**ADDENDUM
NO. 3**

February 2, 2023

**The Riviera Club Aquatics Center
5640 North Illinois Street
Indianapolis, IN 46208**

ADDENDUM NO. 3

5 FOUNDATION SECTION 3/4" = 1'-0"

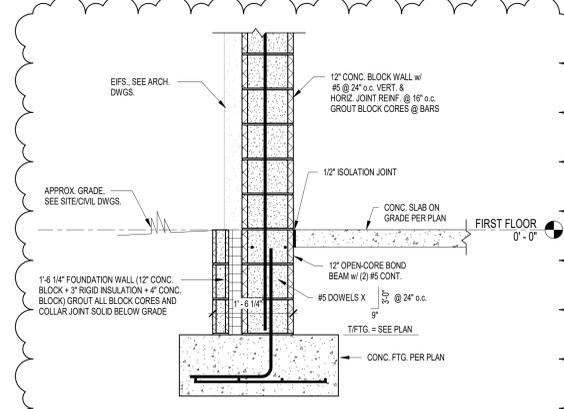
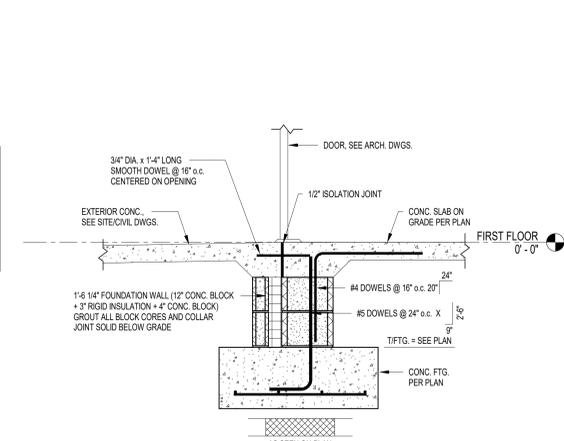
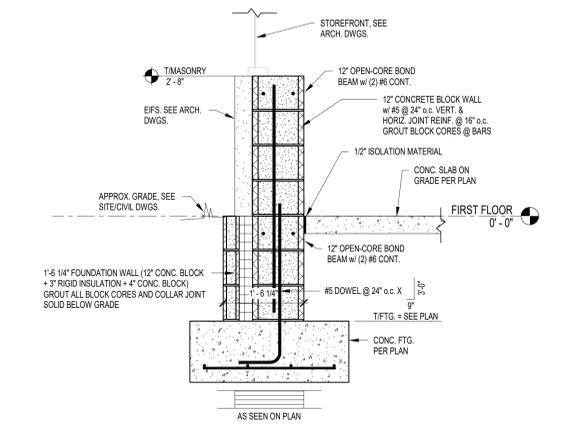
Bid RFI-033	Along with the grouting locations, can you clarify if the foundation on detail 5/S401 is supposed to be a 12" block, 3" insulation, and a 4" block instead of only a 12" and 4" block. I am confused as to why details 3/S401 and 4/S401 show the 12"CMU+3" Insualtion+4" CMU but the detail 5/S401 is only 12"CMU+4"CMU. See pictures below for more clarification.	Response (Answered) from: Jake Shelley (LHB) Remarks: To be addressed in Addendum No. 3.
Bid RFI-034	Substitution Request: 237313 Ice Western Sales	Response (Answered) from: Joyce Myers (KBSO) Remarks: Rejected.
Bid RFI-035	Substitution Request: 237416 Ice Western Sales	Response (Answered) from: Joyce Myers (KBSO) Remarks: Rejected.
